**Re: Thunder Bay Hydro Electricity Distribution Inc.
Application for Rates
Board File Number EB-2016-0105**

Ontario Energy Board Staff Interrogatories
2017 Electricity Distribution Rate Application
Thunder Bay Hydro Electricity Distribution Inc. (Thunder Bay Hydro)
EB-2016-0105
December 20, 2016

Figure 5.2.3-2 Historical SAIDI Performance

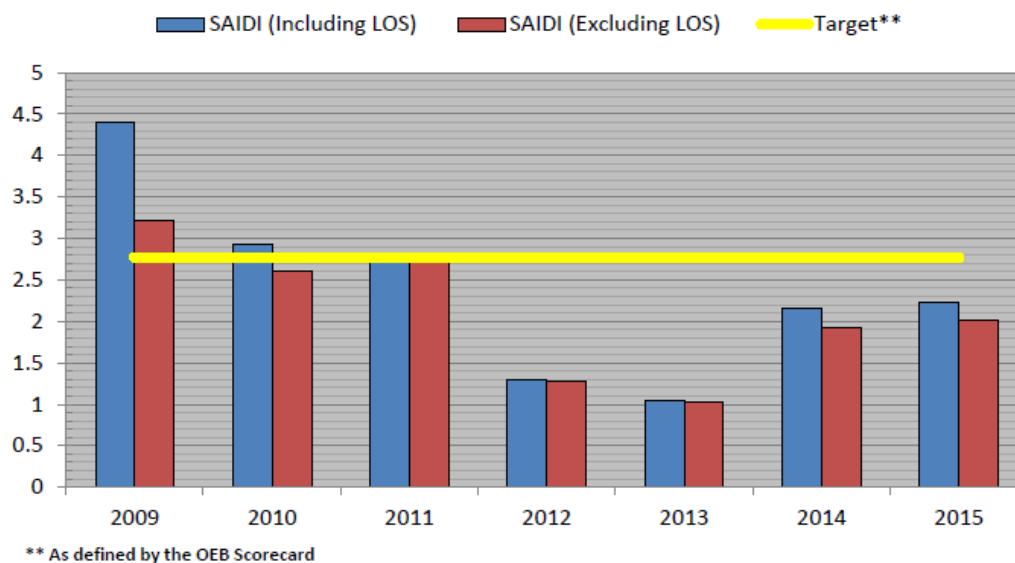
- Please explain the reasons for the comparatively high SAIDI in 2009.
- Please explain the reasons for the step improvement in SAIDI from 2011 to 2012.
- Please explain the reasons for the increase in SAIDI from 2012 & 2013 to 2014 & 2015.

Figure 5.2.3-5 Outage Causes by Duration 2012-2015

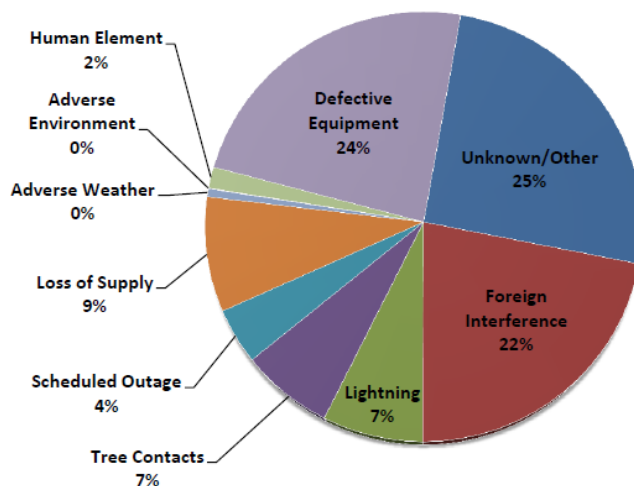
- a) Please explain why 25% of outages between 2012-2015 have unknown causes.
 - i. Would a 25% proportion of unknown outage causes be typical among Thunder Bay Hydro's peers?
 - ii. Does Thunder Bay Hydro have any insights as to the likely drivers for the unidentified cause outages?
- b) What steps, if any, is Thunder Bay Hydro taking to identify the causes of such outages going forward?

Figure 5.2.3-6 Total Cost per Customer 2012-2014 (2015 not available at time of writing)

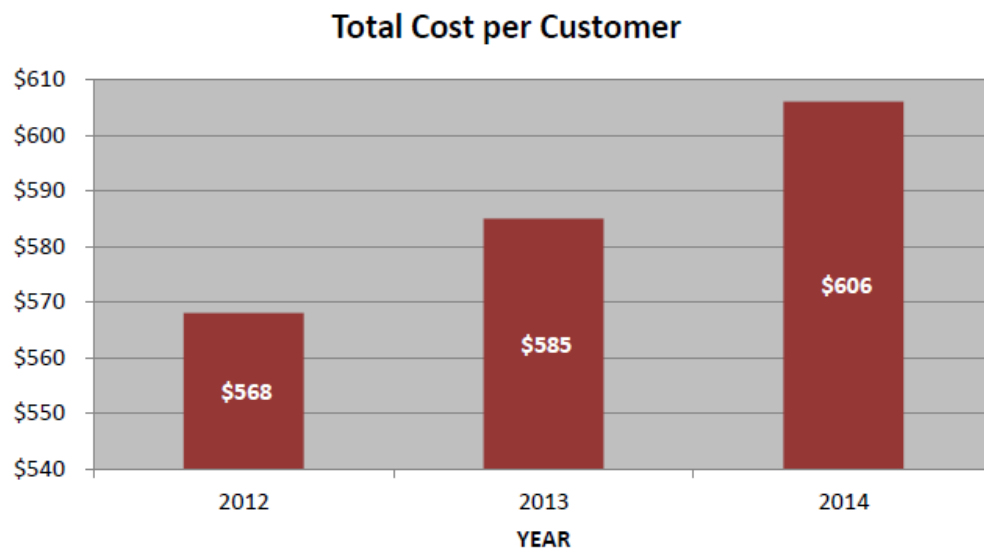
- a) Is the 2015 total cost per customer now available?
 - i. If yes, please provide an updated figure showing this information.
 - ii. If no, please provide estimated total cost per customer in 2015.

Figure 5.3.1-2 Health Index Results Summary 2015

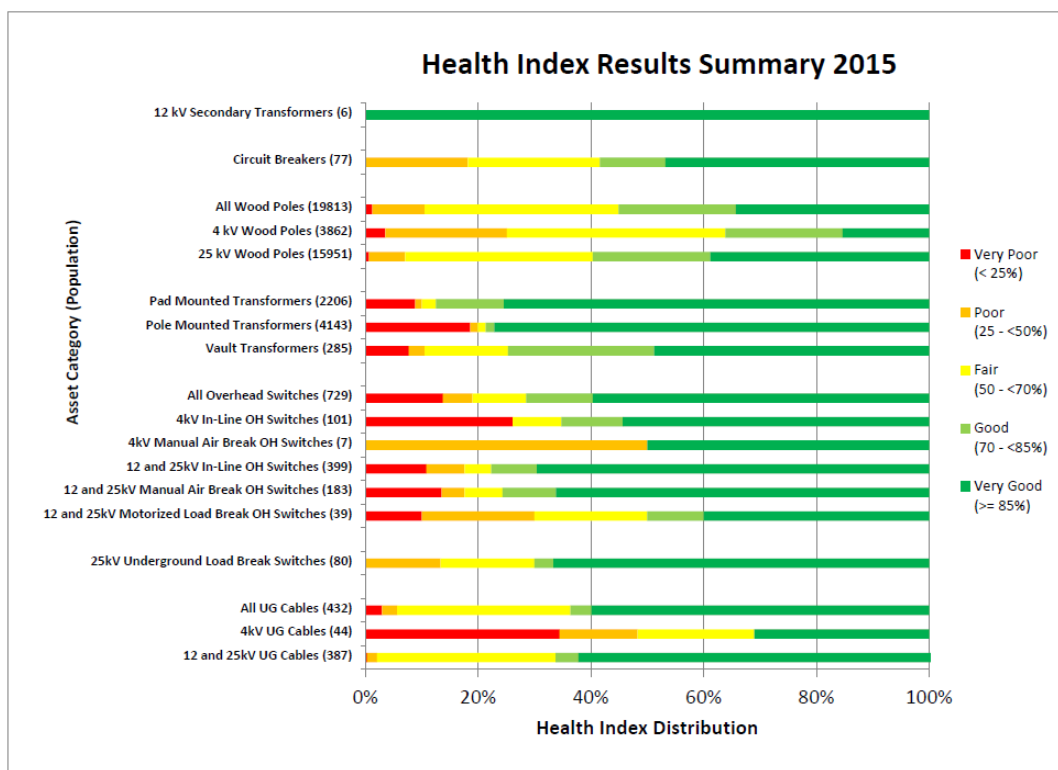
- a) In Figure 5.3.1-2 above, please confirm that the 12 kV Poles are included with the 25 kW Wood Poles.

- i. If not confirmed, please explain how 12 kV poles are accounted for in this figure.
- b) Please confirm if the total of 432 is correct for All UG Cables (i.e.: 44 UG Cables @ 4 kV plus 387 UG Cables @ 12 & 25kV = 431 UG Cables).

Figure 5.3.2-1 - Kinectrics ACA Wood Pole Health

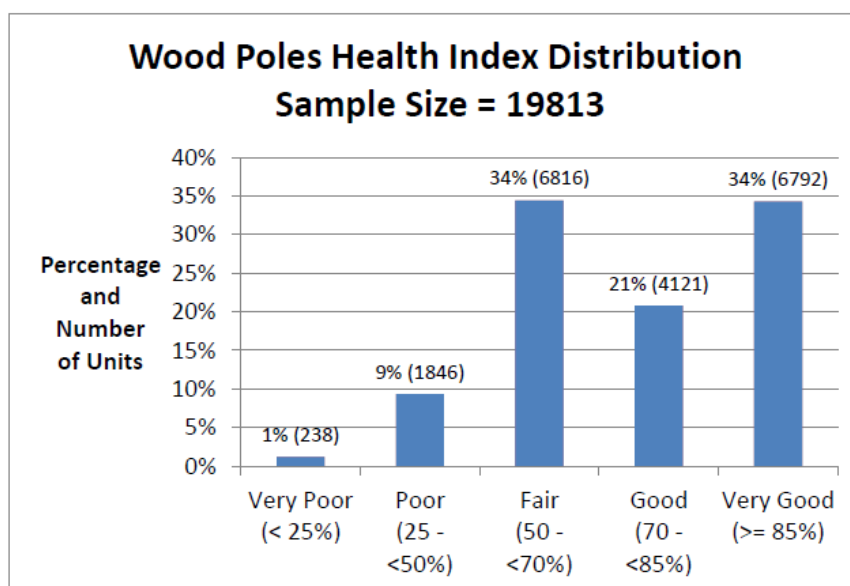
Please reconcile the wood pole health index distribution with Thunder Bay Hydro's 700 pole per year replacement target.
